Project	IEEE 802.16 Broadband Wireless Access Working Group	
Title	Functional Requirements for the 802.16.3 Interoperability Standard	
Date Submitted	2000-06-23	
Source	Brian Petry (editor) 3Com 12230 World Trade Dr. San Diego, CA 92128	Voice: (858) 674-8533 Fax: E-mail:brian_petry@3com.com
Re:	<p>This is a collaborative effort by the 802.16.3 Functional Requirements Task Group which started from a contribution by George Fishel and was further revised by the task group by a formal comment/resolution process. Please be sure you are reading the most recent published version of this document (802.16.3-00/02rx where x is the version number) which can be found at: http://ieee802.org/16/sub11/index.html</p> <p>This document is input to 802.16 session #8 (10-14 July, 2000). It contains edits that have been reviewed and resolved by the 802.16.3 task group at session #7.</p>	
Abstract	<p>This document provides functional requirements that are guidelines for developing an interoperable 802.16.3 air interface. The 802.16.3 committee desired to reach an understanding and consensus for functional requirements before proceeding with developing standards for 802.16.3 MAC and PHY protocols and thu

1 Figure 2-2: System Reference Points [E; Goldhammer: change “voice data and video”
2 to “data voice video”] [T; Freedman: Add optional Central Control Station and more
3 base station to diagram] [T; Trinkwon: Amend Figure 2-2 to show :

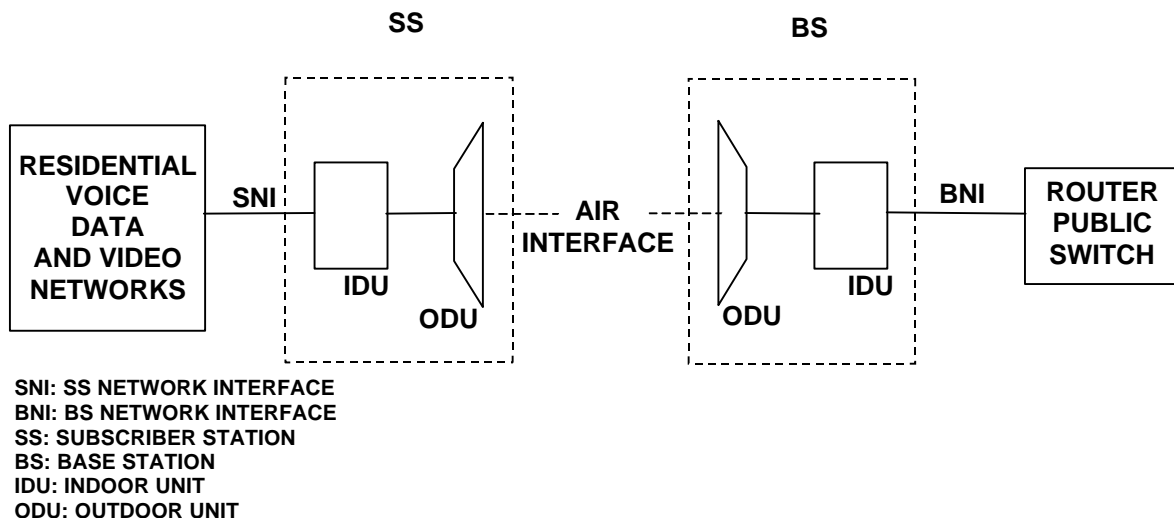
4 a) Local Power within the SS box, supplying the IDU and ODU.

5 b) Multiple ODU's per IDU at the BS

6 c) Remote IDU's from the BS IDU. These Remote units / antenna would be located
7 away from the BS site to improve coverage / economics in range or capacity limited
8 deployments.

9
10 d) The BS IDU might not be located at the BS - it might be at another location (which
11 might be the same as the public switch / router)

12
13 e) The switch / router might not be public - it might be a private / corporate edge device
14 which might, or might not have public network gateways / connections behind it.

15 [T; Kasslin: In Figure 2-2 delete the drawings inside the SS and BS boxes
16 and delete the terms IDU and ODU.]

17
18 [T; Wachira: Remove references to ODU and IDU]
